City of Detroit  
Inter-Departmental Communication

**RE:** Petition No. 512  
Request to Outright Vacate The North/South Alley In The Block Bound By  
Bagley, Vermont , Marantette, And Rosa Parks Blvd.

**NOTICE OF PROPOSED CHANGE IN PROPERTY**

<b>B</b>						<b>REQUEST TO OUTRIGHT VACATE          THE NORTH/SOUTH PUBLIC ALLEY, 20 FT. WD.          IN THE BLOCK BOUND BY          BAGLEY ST, VERMONT, MARANTETTE AVE.          AND ROSA PARKS BLVD.</b>	<b>CITY OF DETROIT          CITY ENGINEERING DIVISION          SURVEY BUREAU</b>
<b>A</b>							<b>JOB NO. 01-01</b>
<b>DESCRIPTION</b>		<b>DRWN</b>	<b>CHKD</b>	<b>APPD</b>	<b>DATE</b>		<b>DRWG. NO. X 512</b>
<b>REVISIONS</b>							
<b>DRAWN BY</b>	WLW	<b>CHECKED</b>		KSM			
<b>DATE</b>	10-05-18	<b>APPROVED</b>

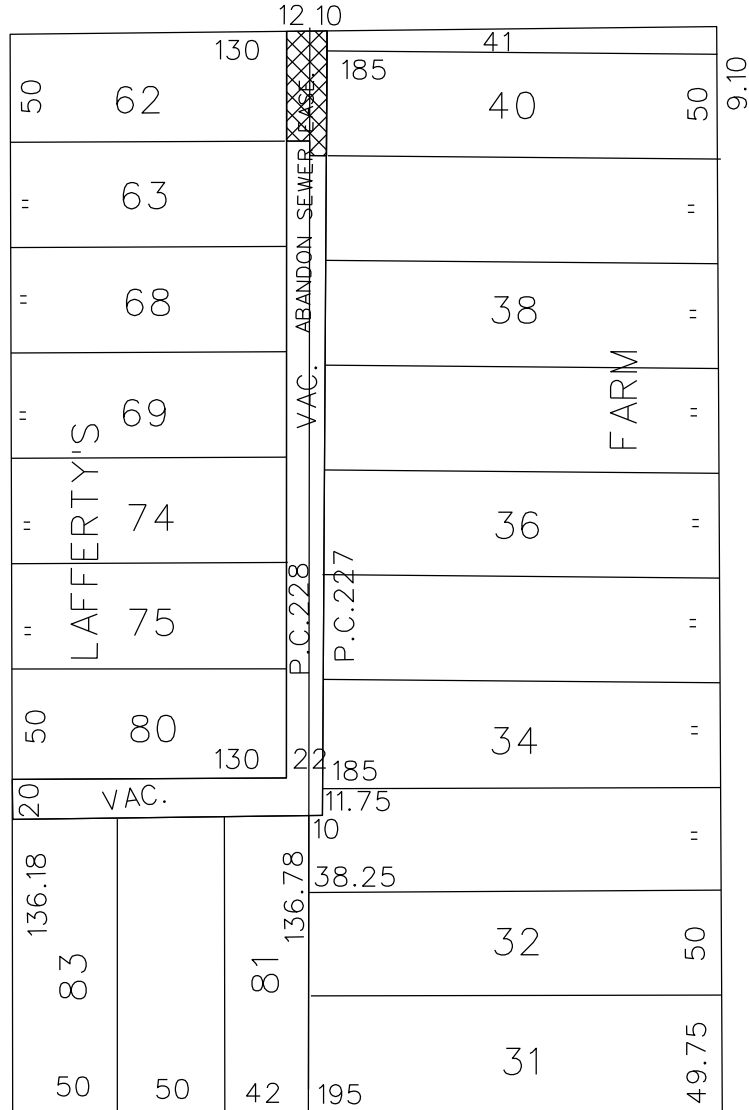
The Detroit Water and Sewerage Department (DWSD) is in receipt of the subject petition. There is a sewer located in the alley. DWSD has no objection to the requested vacation provided that the following conditions are met:

- The sewer services no other properties and only services the properties owned by the Petitioner, if not the Petitioner must prepare a relocation plan for the sewer signed by a Registered Engineer, DWSD approves the relocation plans, and the Petitioner grants a satisfactory easement for the relocated sewer. The Petitioner is to bear the entire cost of the proposed relocation plans, including construction, demolition, permitting, inspection, survey, etc.
- If DWSD is to maintain ownership of the existing sewer a satisfactory easement is to be granted by the Petitioner.

The entire work is to be performed in accordance with DWSD specifications and standards, all of the fees are to be deposited with DWSD in advance, to cover the necessary costs of permits and inspection.

Provided that the petitioner shall design and construct proposed sewers and to make the connections to the existing public sewers as required by the Detroit Water and Sewerage Department (DWSD) prior to construction of the proposed sewers,

Provided that the plans for the sewers shall be prepared by a registered engineer; and further

Provided that DWSD be and is hereby authorized to review the drawings for the proposed sewers and to issue permits for the construction of the sewers, and further

Provided that the entire work is to be performed in accordance with plans and specifications approved by DWSD and constructed under the inspection and approval of DWSD; and further

Provided that the entire cost of the proposed sewers construction, including inspection, survey and engineering shall be borne by the petitioner; and further

Provided that the petitioner shall deposit with DWSD, in advance of engineering, inspection and survey, such amounts as the department deems necessary to cover the costs of these services; and further

Provided that the petitioner shall grant to the City a satisfactory easement for the sewers; and further

Provided that the Board of Water Commissioners shall accept and execute the easement grant on behalf of the City; and further

Provided, that the petitioner shall provide DWSD with as -built drawings on the proposed sewers; and further

Provided that the petitioner shall provide a one (1) year warranty for the proposed sewers; and further

Provided that upon satisfactory completion, the sewers shall become City property and become part of the City system. And any existing sewers that were abandoned shall belong to the petitioner and will no longer be the responsibility of the City.
